Access Compliance Report

Public Rights-of-Way

(Curb Ramps)

Intersection ID: 50272	Main Street: SOUTH_BV	Cross Street: WHITTON_ST	Location: S
ADA ID: 6F2F475EFF45	Ramp Type: BlendTrans1	Initial Pass/Fail: Pass	Overall Compliance: No
		Severity Score: 7.5

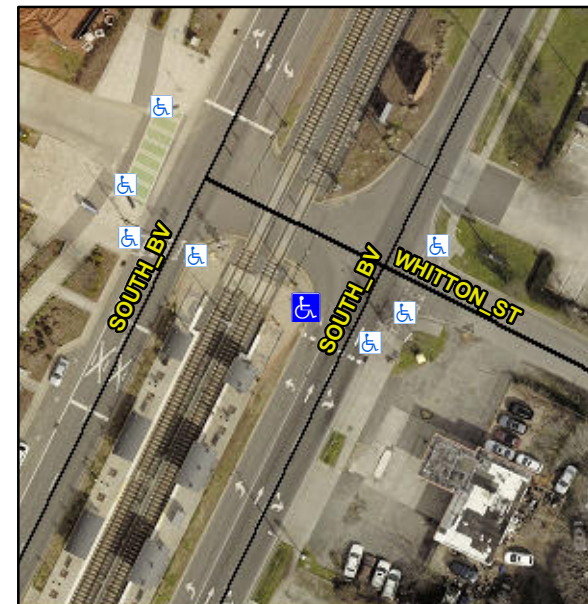
Not Found, R304.5.3, R305.1.4, R304.5.4

Yes	Ramp inside XWalk1?	Yes	N/A	Ramp inside XWalk2?	N/A
	Road Slope (%)	0.6		Clear Space?	Yes
	Road X Slope (%)	1.5	N/A	Clear Space to XWalk (in)	N/A
Yes	Any Obstructions?	No	Yes	Storm Grate/Utility Hazard?	No
	Obstruction Type			Storm Grate/Utility Type	
		N/A			N/A
			Yes	Surface Condition? (G/P)	Good
			No	Curb Slope (%)	7.4

Remove & Replace Curb Ramp With Two New Directional Ramps or Equivalent. Remove & Replace Gutter.
